ADDENDUM NO. 1

DNR-250004 GREAT COUNCIL OBSERVATION TOWER

1587 US-68,
Xenia, OH 45385

FOUNDATION PLAN

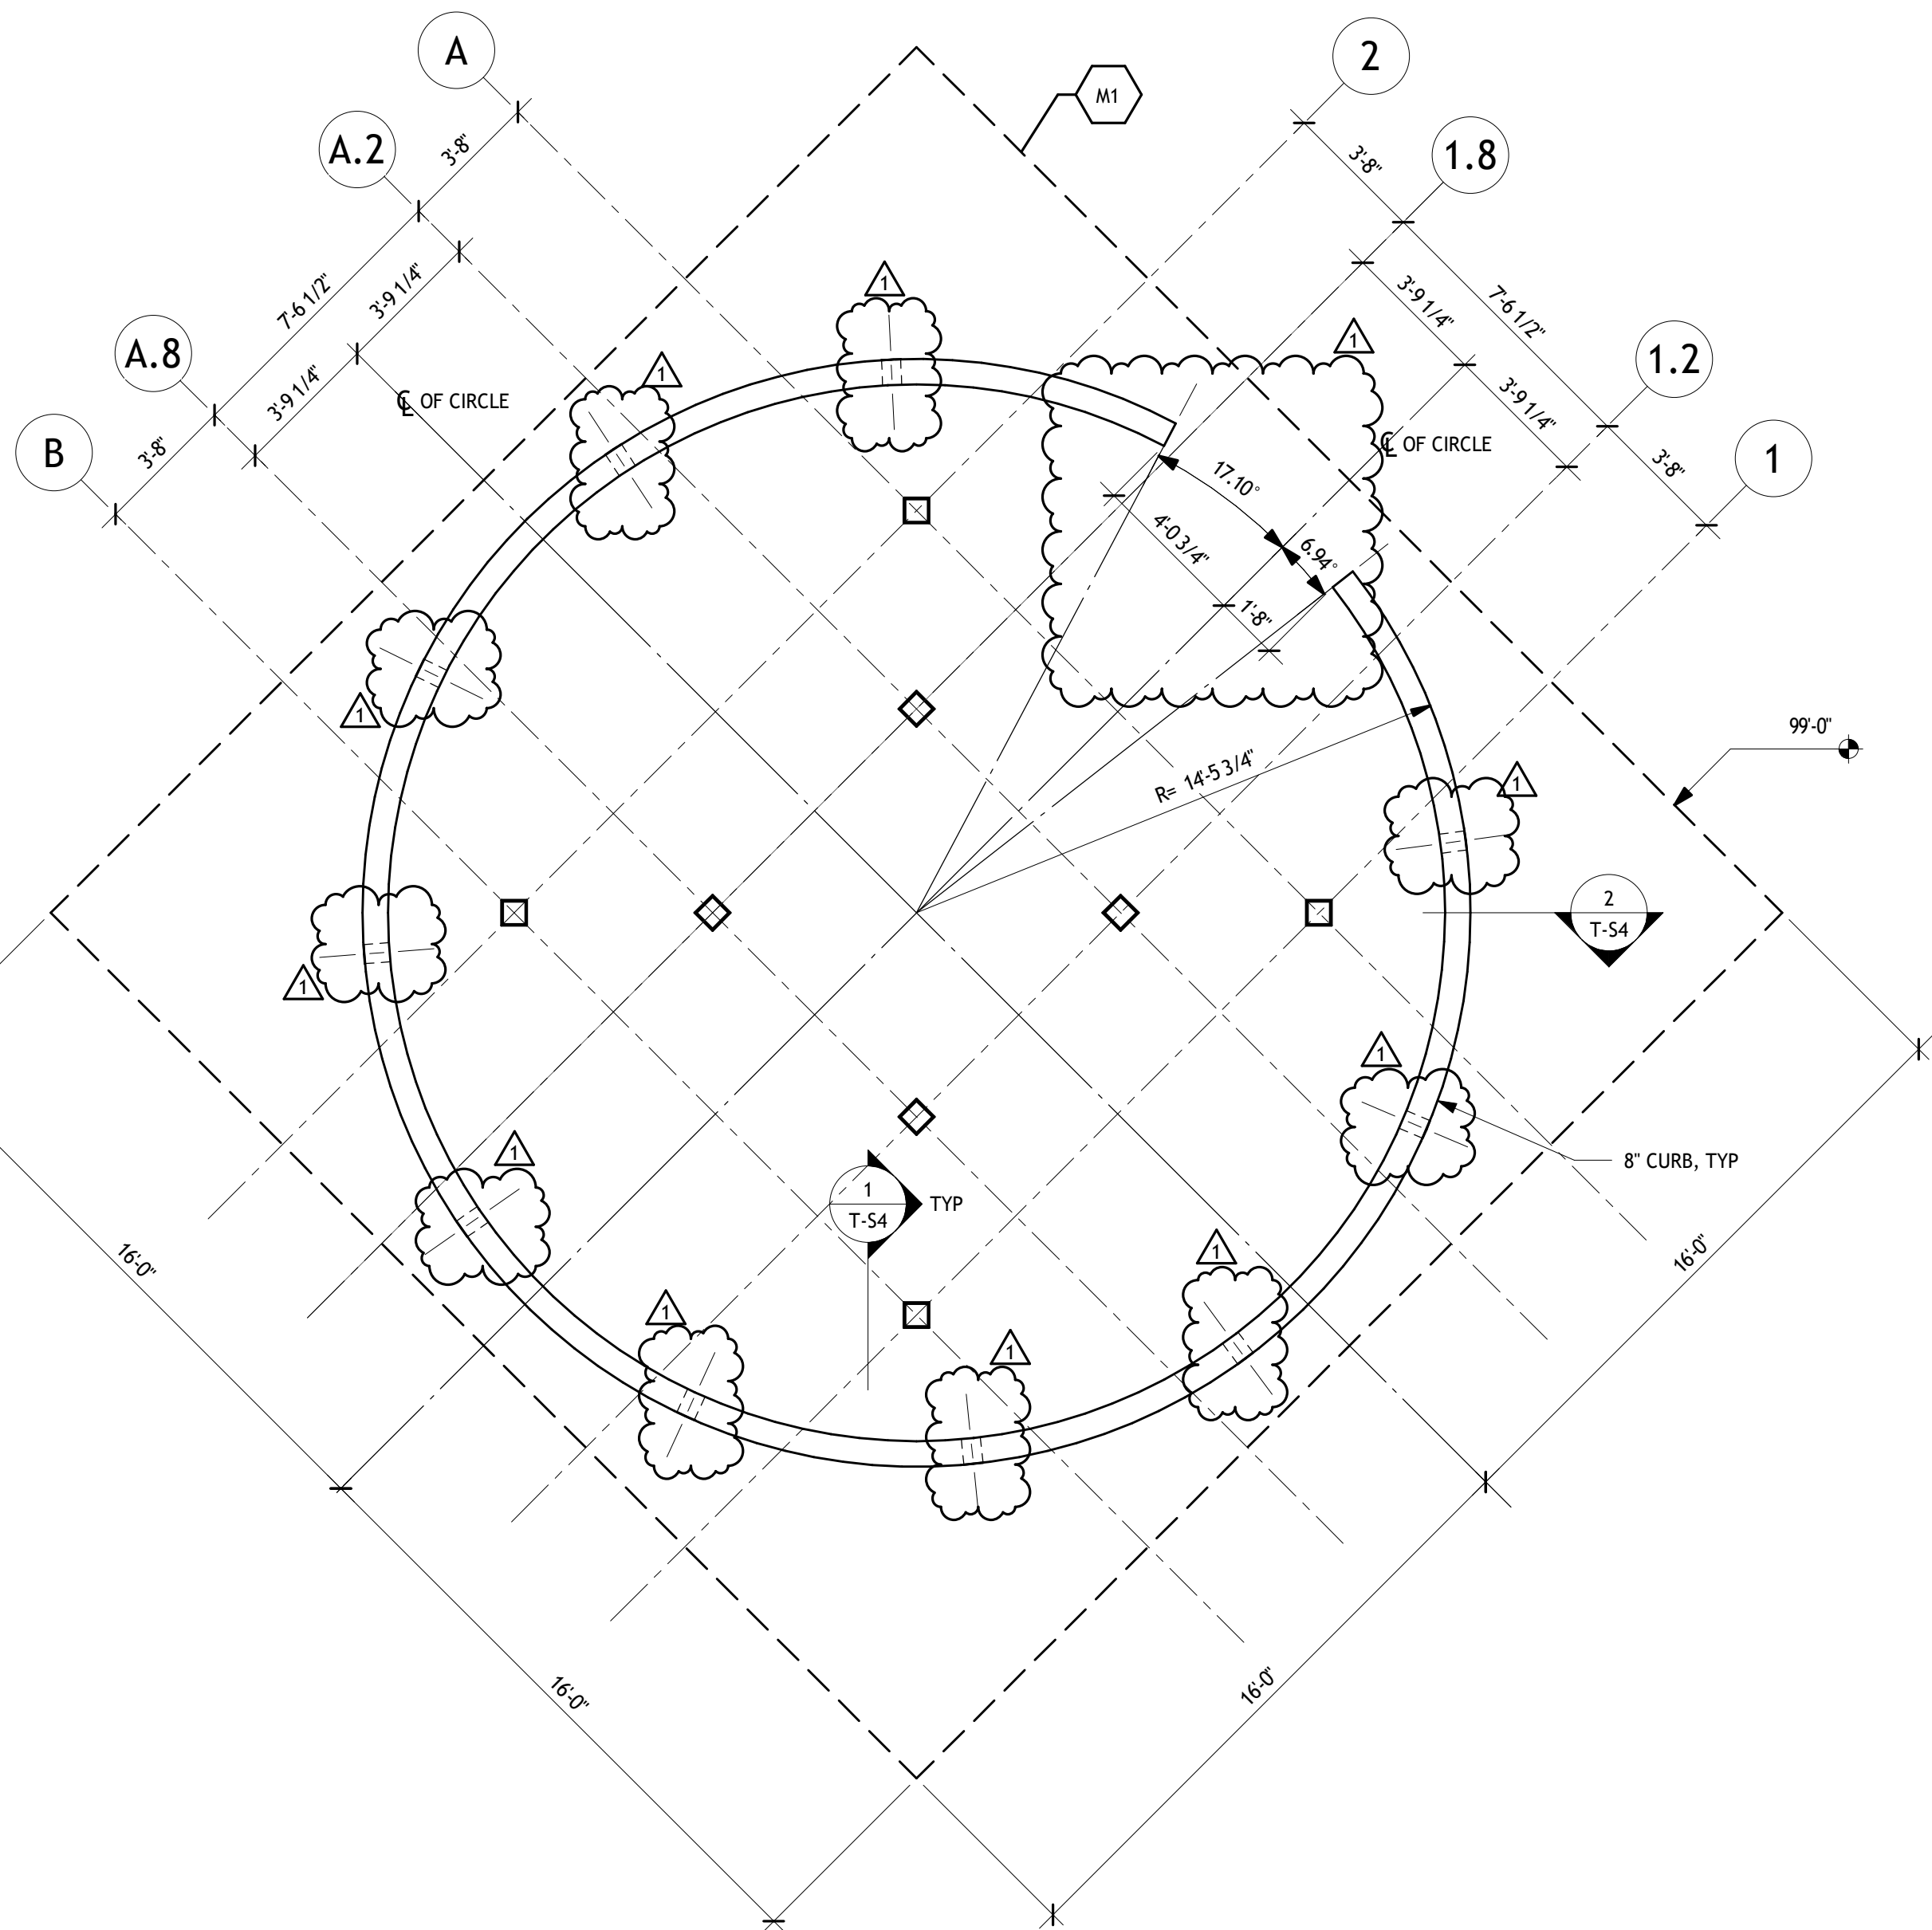
ITEM 13 T-S4 – FOUNDATION PLAN & DETAILS

Added leave-outs at elevation 100'-0" at 8'-0" c/c maximum.

5 DOMESTIC ISOMETRIC

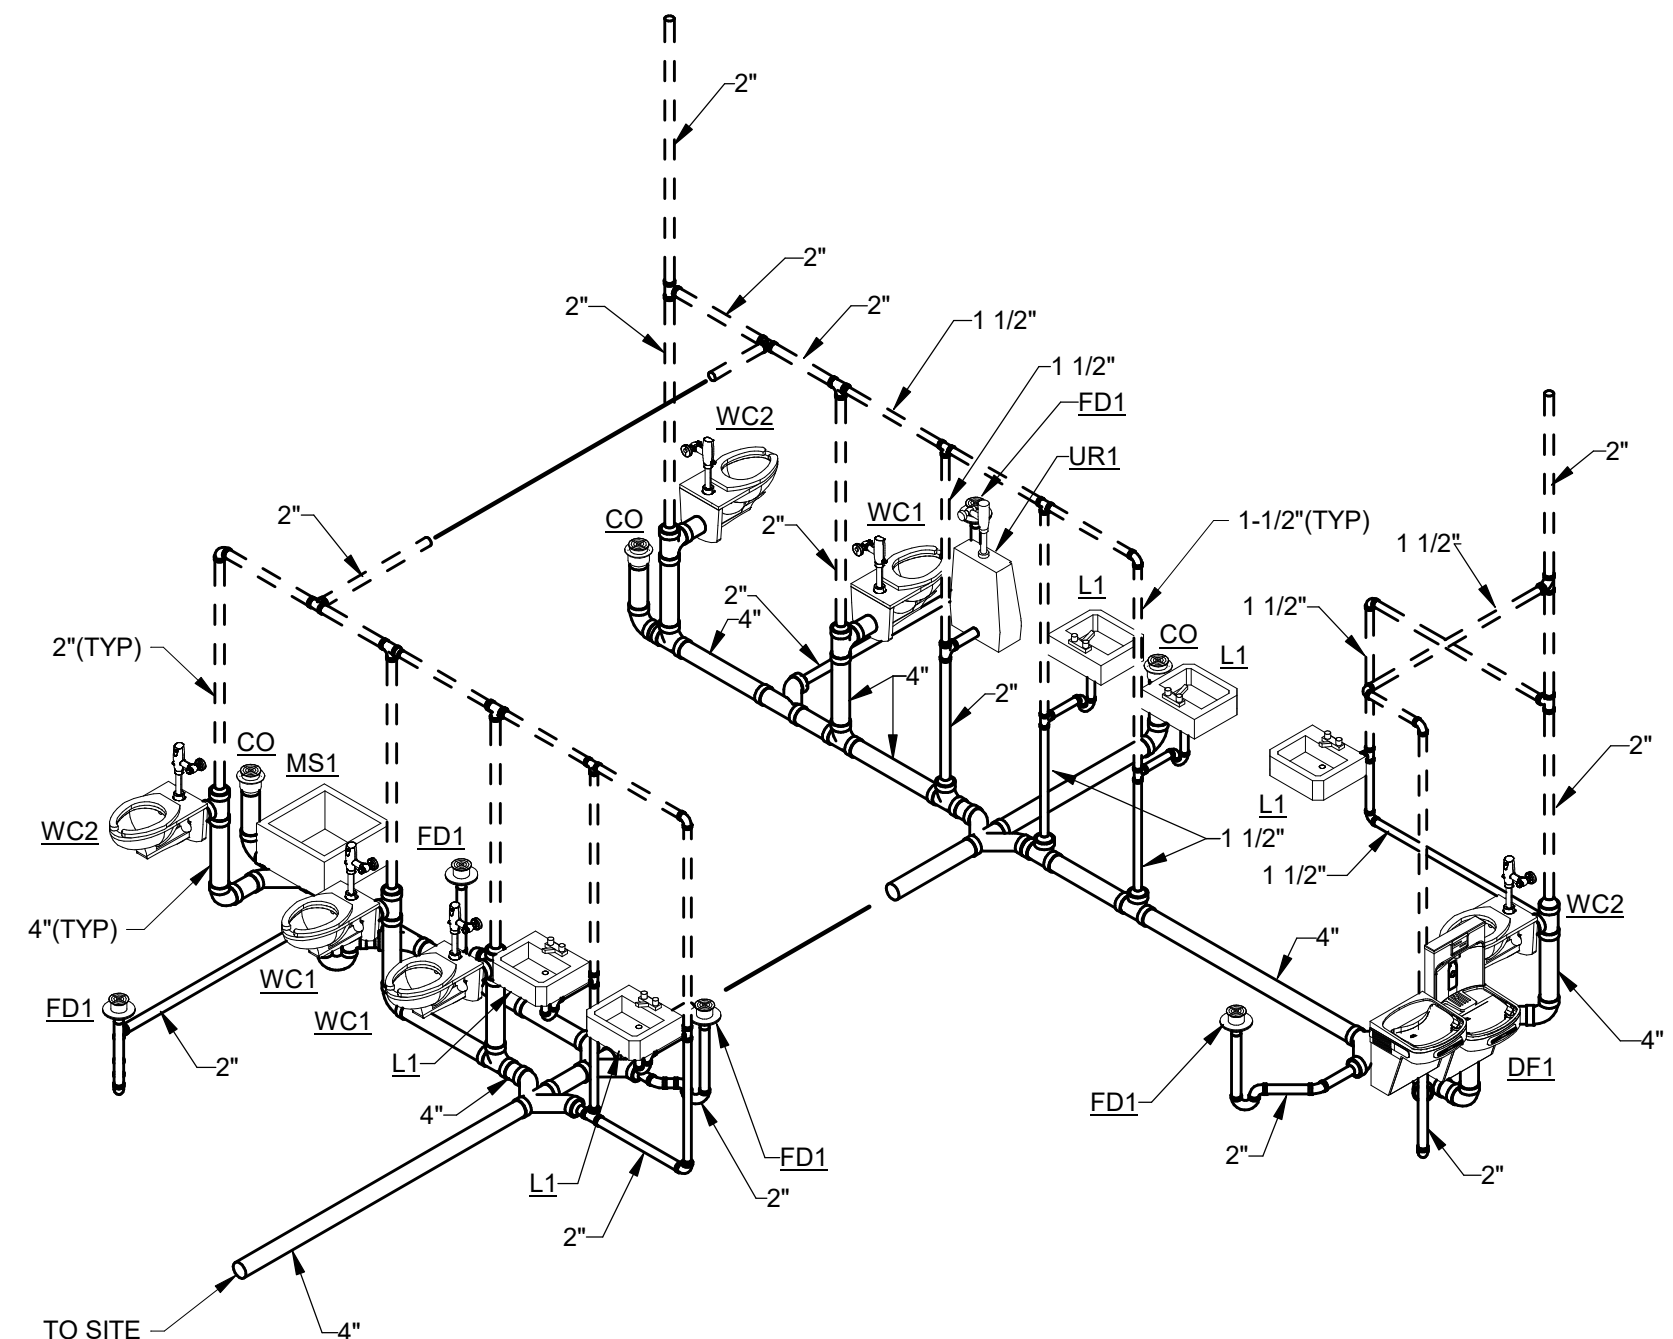
ITEM 15 P101 – FIRST FLOOR PLAN PLUMBING

Added General sheet note to read, "IT IS THE DESIGN INTENT THAT EACH RESTROOM'S WATER SUPPLY SHALL BE ABLE TO BE SHUT DOWN INDEPENDENTLY FOR WINTERIZATION. PROVIDE SHUT OFF VALVES AND AIR COMPRESSOR FITTINGS AS NECESSARY."

Revised Domestic Isometric 5.

2 FIRST FLOOR PLAN - POWER AND SYSTEMS
1/4" = 1'-0"

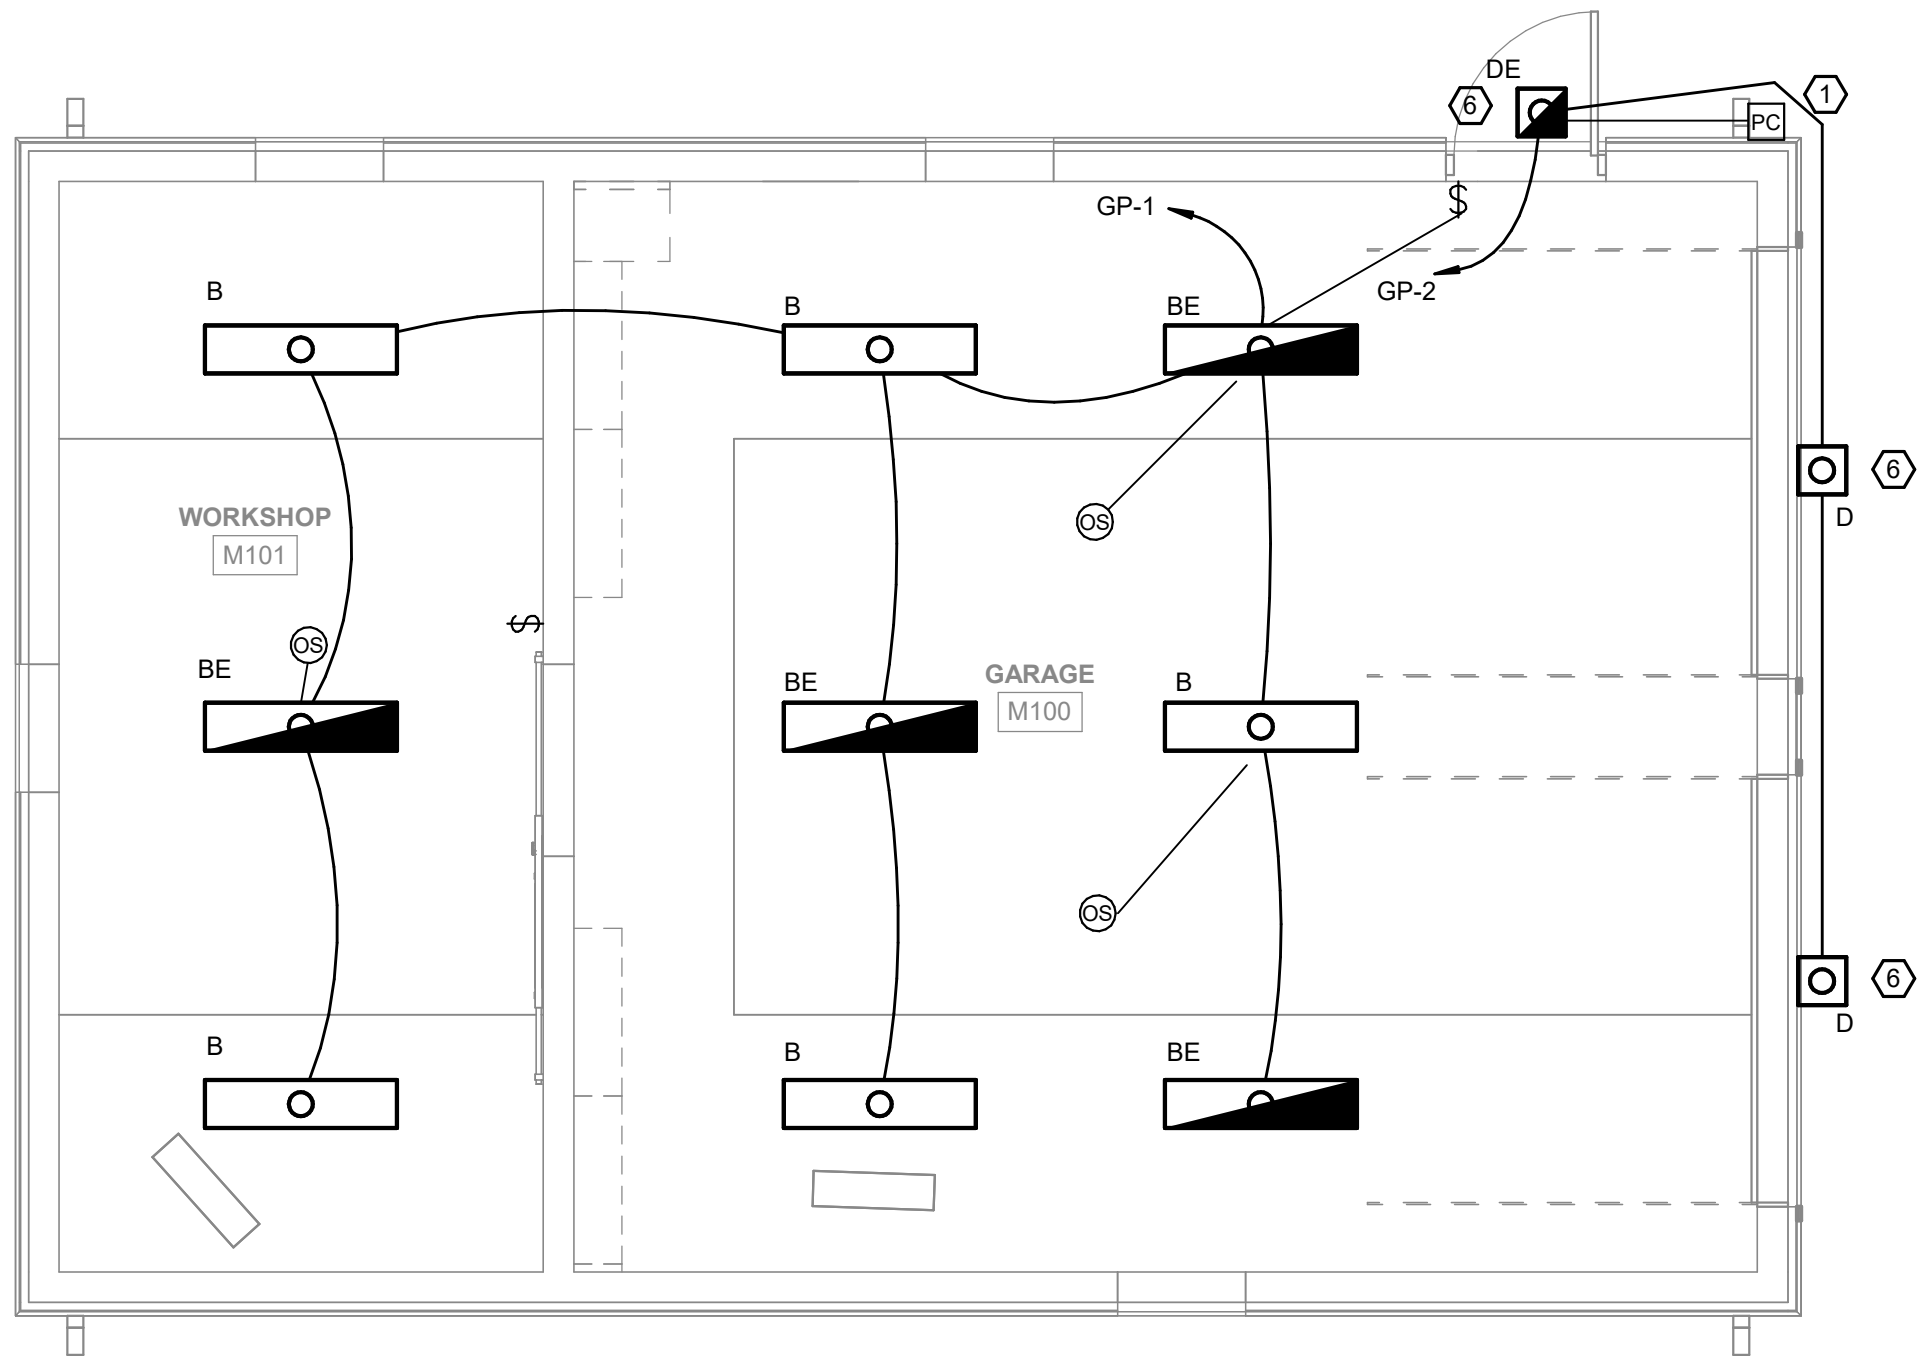
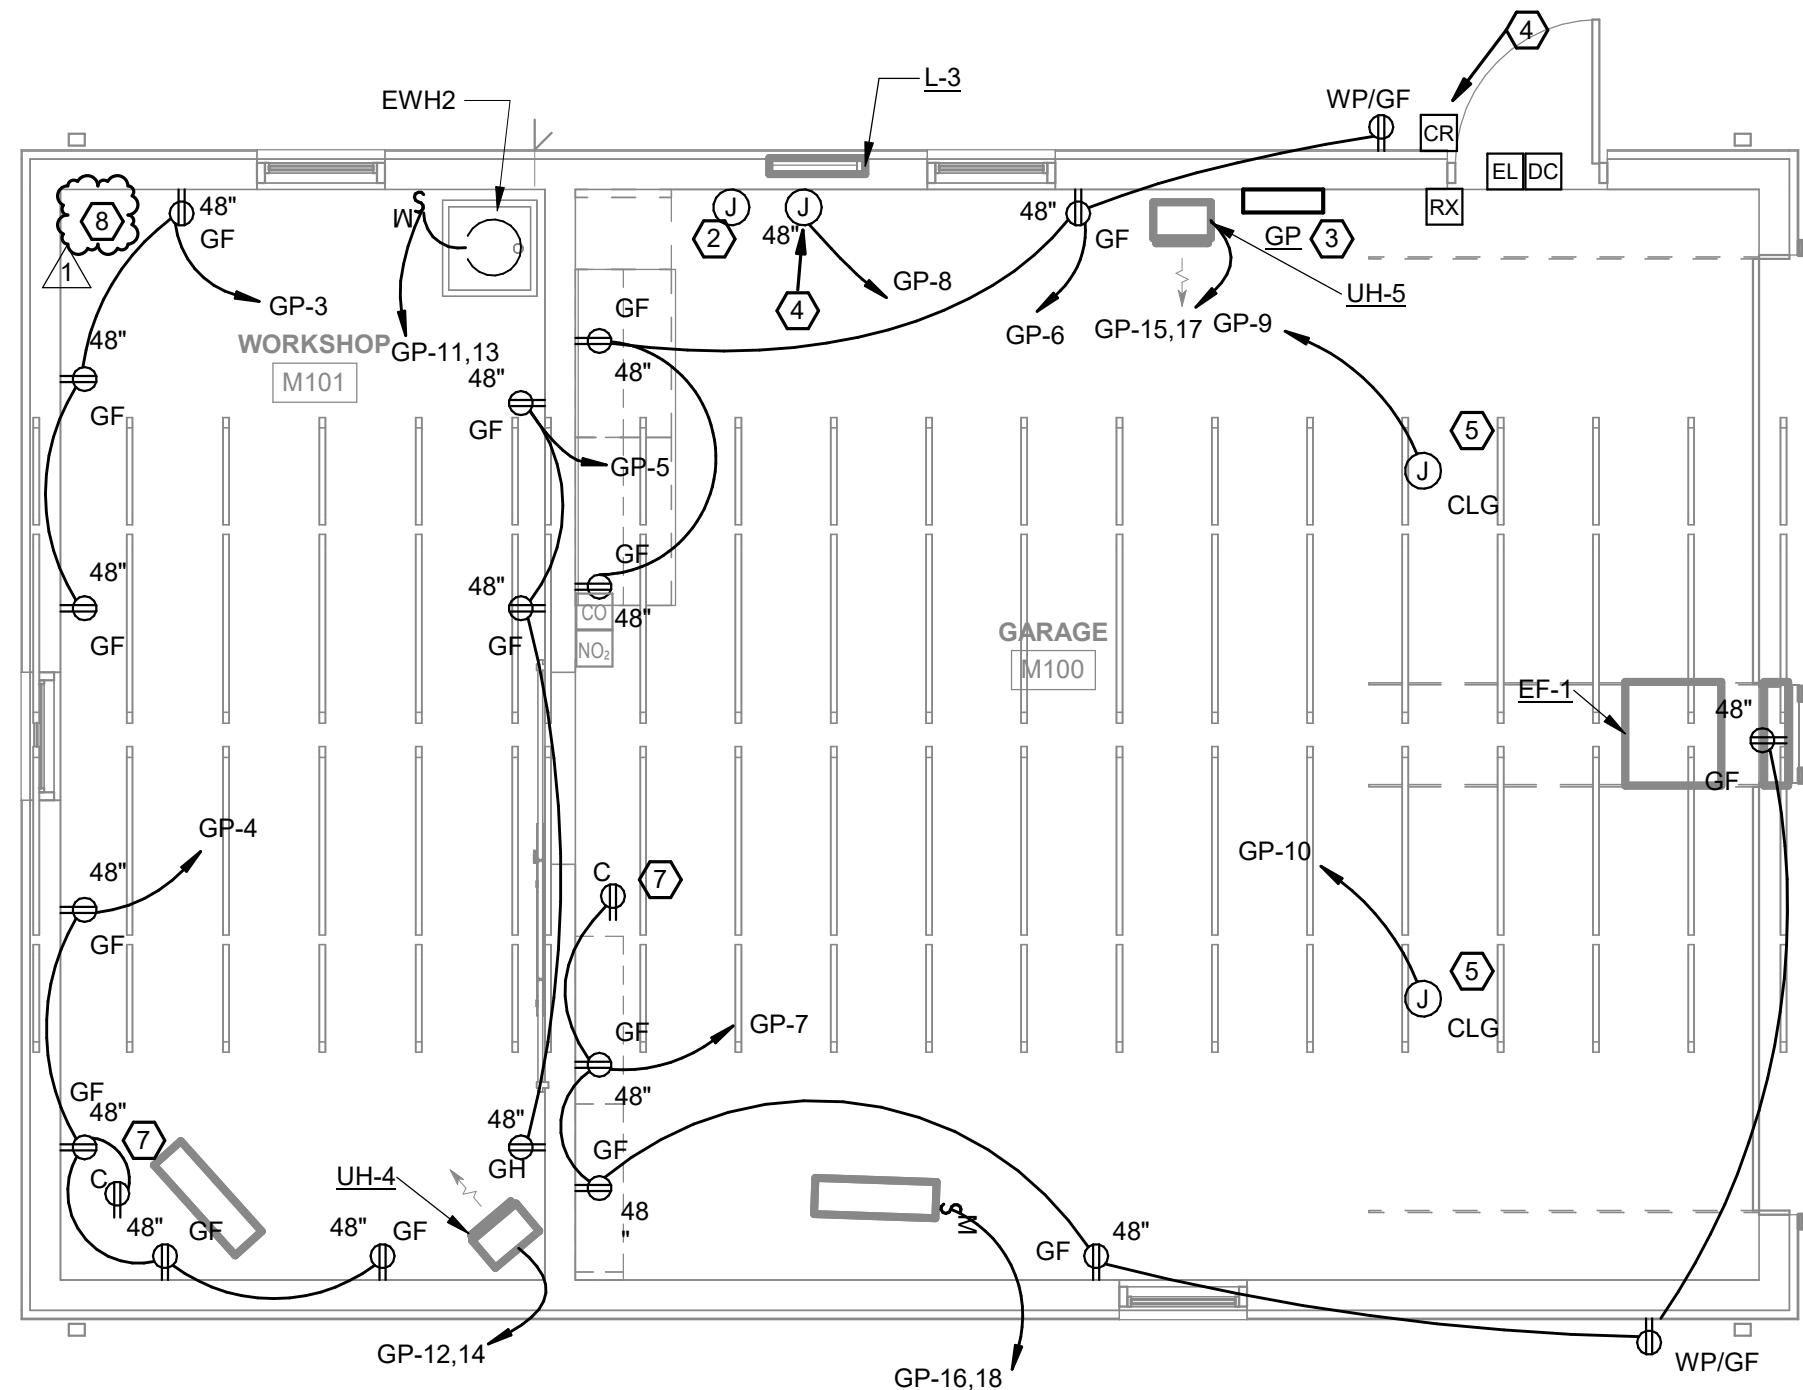
ITEM 18 E201 – FLOOR PLAN - ELECTRICAL

Added Keynote note 8 to read, “APPROXIMATE LOCATION OF OWNER COMMUNICATION EQUIPMENT. STUB CONDUITS UP IN CORNER OF ROOM. CONFIRM EXACT LOCATION WITH OWNER PRIOR TO ROUGH-IN.”

Revised keynote 5.
